Service Bulletin

RRP Service Bulletin No: RRP SB410

Title: Left and Right Outer Jack Tubes updated with additional reinforcement

Product Series: Advance Tie Plate Inserter [ATPI]

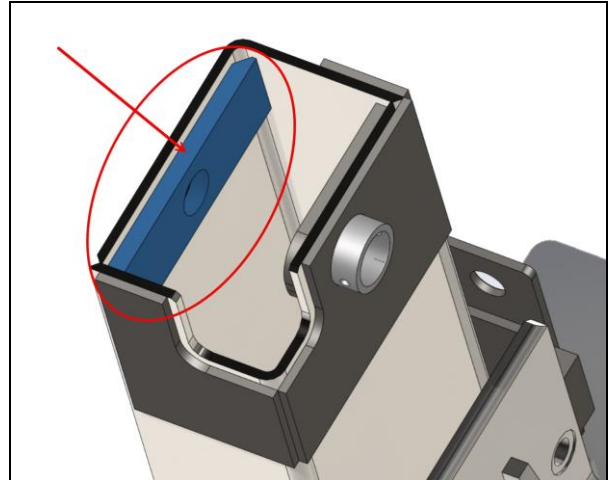
Summary: Outer Jack Tubes: Left **RRP# 780865** & Right **RRP# 780866** have been updated to Rev. 4 with additional reinforcements to prevent possible breakage.

Action: Check the left and right Outer Jack Tubes for damage (cracking / fatigue). If necessary, replace the old outer jack tubes with the updated version, Rev. 4: Left **RRP# 780865** & Right **RRP# 780866**.
